S E R V I C E N O T E

37714A PDH/SDH/Jitter Test Set

Upgrading the Instrument Firmware

DATE: January 1996

Figure 1 - Location of ROM DRAWER (37714-60005)

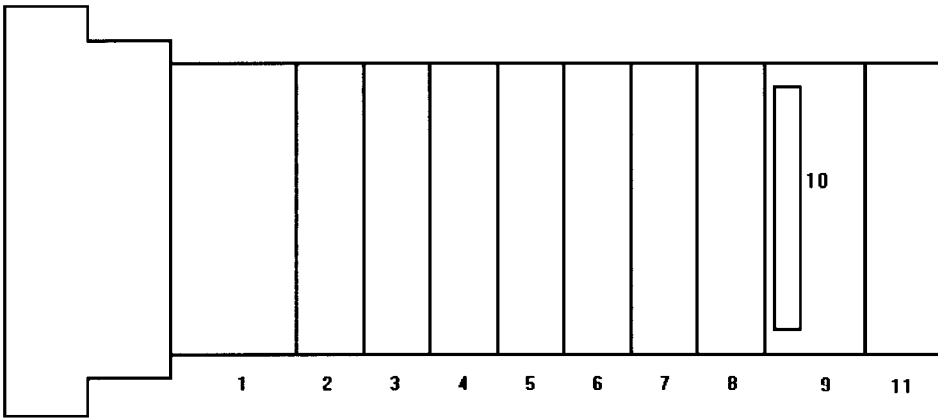
1. Switch off the 37714A and disconnect the power cord.
2. Remove the two screws securing the ROM Drawer Cover to the CPU Module (see Fig 1 below) and carefully extract this drawer out of the module.
3. Remove eeproms A5 U1, U2 (and U3 and U4 if fitted) from their sockets and replace with the new eeproms.

4. Fit the ROM Drawer Assembly into the instrument, replace the ROM Drawer cover and secure with the two screws.

Figure 2 Location of eeproms in ROM Drawer.

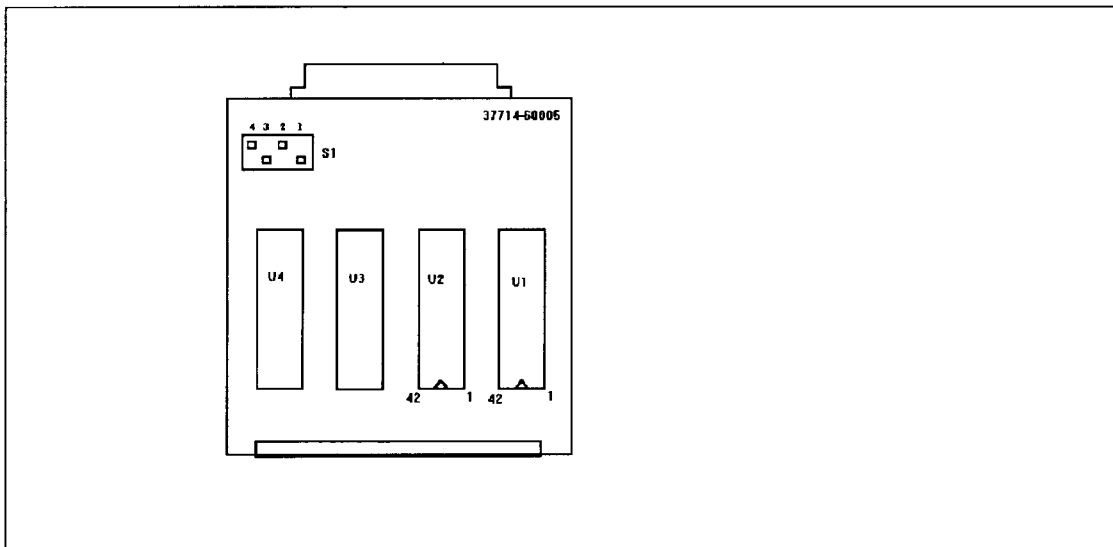
Take care to insert these eeproms in the correct position Refer to Figure 2.
